United States Patent and Trademark Office

APPLICATION NO.	FILING DATE	FIRST NAMED INVENTOR	ATTORNEY DOCKET NO.	CONFIRMATION NO.
09/374,681	09/19/2002	CRAIG H. BAKER	81762/210 4027	
7	590 12/14/2005		EXAM	INER
GUNNER G. LEINBERG, ESQ. NIXON PEABODY LLP CLINTON SQUARE			TSUKERMAN, LARISA Z	
			ART UNIT	PAPER NUMBER
P.O. BOX 310:			2833	
ROCHESTER,	, NY 14603		DATE MAILED: 12/14/2005

DETAILED ACTION

Attachment 1

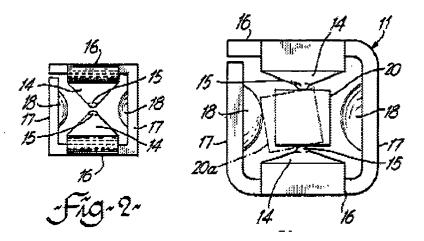
an electrically conductive body 11 having a pin contact engaging bore (not marked, see Attachment) which extends at least partially along a first axis, the body 11 comprising:

at least two pin contact arc receiving elements 18 (see Attachment 1, read on applicant's left and right guide portions 18) extending into the bore, wherein the arc receiving elements 18 are spaced apart across the bore and having a distance that is greater than a maximum transverse dimension of the pin contact 20 (shown in Fig.3), and

In regard to claims 3 and 10, Ostapovitch also discloses the pin contact arc receiving elements 18 comprises stamped or curved inwardly extending projections (Fig. 1 and 3 and Attachment 1).
